Delegated Report (Refusal)		Analysis sheet		Expiry Date:	09/08/21
				Consultation Expiry Date:	12/07/21
Officer			Application Number(s)		
Ewan Campbell			2021/1761/P		
Application Address			Drawing Numbers		
83 Jamestown Road London NW1 7DB			Existing/519-100-E, Existing/519-101-E, Existing/519-200-E, Existing/519-300-E, Proposed/519-101-E, Proposed/519-200-P and Proposed/519-300-P		
PO 3/4	Area Team Signature	C&UD	Authorised Officer Signature		
Proposal(s)					
Conversion of flat roof to roof terrace accessed by new openable roof light, installation of new internal space-saving stairs to roof to provide roof access and installation of security steel railing.					
Recommendation(s):		Refuse Full Planning Permission			
Application Type:		Full Planning Permission			
Reasons for Refusal:		<ul style="list-style-type: none"> The proposed roof terrace on top of the mansard roof extension, by virtue of its design, location, scale and bulk, would result in a incongruous and dominant addition to the existing dwelling which would detract from the character and appearance of the locally listed building and the wider area, contrary to policy D1 (Design) and D2 (Heritage) of Camden's Local Pla

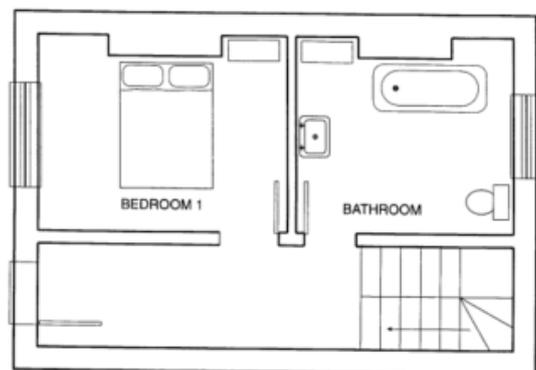
2.2.3 The property to the west cannot be used as a precedent as it is not part of the historic terrace which runs from no.83 to No.61. A roof terrace would be completely alien to the 19th architectural aesthetic of this well-kept terrace and indeed would set the precedent that the street currently does not have. This terraced is architecturally significant with non-designated heritage asset status and so the harm to the building and wider area (which includes the rest of the terrace) has been balanced under 203 of the NPPF (2021). Creation of a roof terrace comes with the likelihood of additional domestic clutter. Such visual intrusion will be harmful to the character and appearance of the streetscape, terrace, and possibly result in incremental harm to the setting of the Listed Building on the other side of the road.

18 OVAL ROAD NW1
 DRS &
 EXISTING FLOOR PLANS
 SCALE 1:50
 HU MACKIE JANUARY 2003

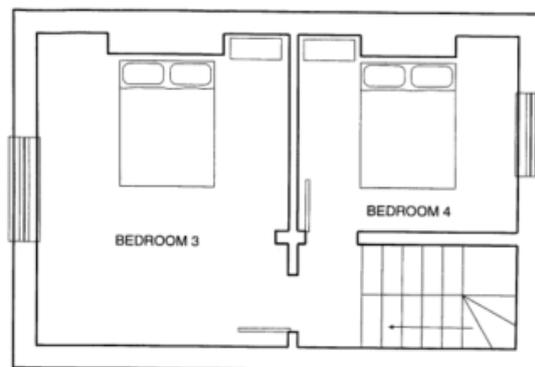
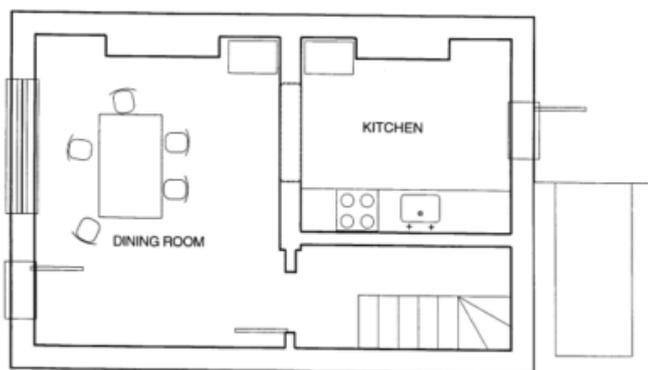
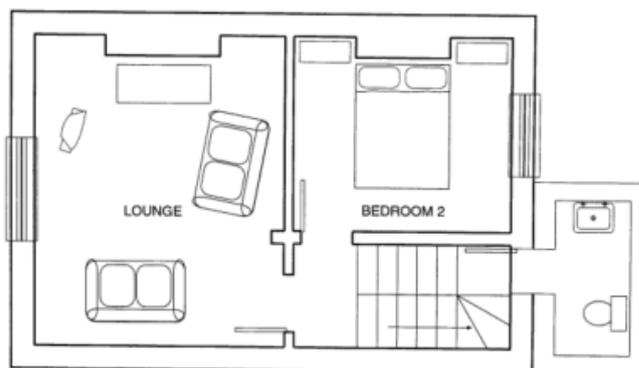
2.3.2 In terms of the proposal, there are a number of issues that impact the amenity of occupants in the neighbouring buildings. For the occupants at Jamestown Road and no.14, 16, 18, 20 Oval Road, the

windows are approximately 7.9m from the middle of the where the roof terrace is and only 5.7m from the south west corner. This means that that the residents of the site can view directly into the rooms which very close to the roof terrace meaning that it contributes to loss of a privacy and increases the perceived overlooking. Looking at a historic planning application for 18, Oval Road (PEX0300126) the windows benefit bedrooms and therefore the proposal will impact habitable rooms. Whilst the area is a tight urban grain and some level inter-viewing between properties is to be expected, the location is extremely prominent and the harm both to actual and perceived overlooking, is unacceptable in this particular case. A screenshot of the plans is provided below:
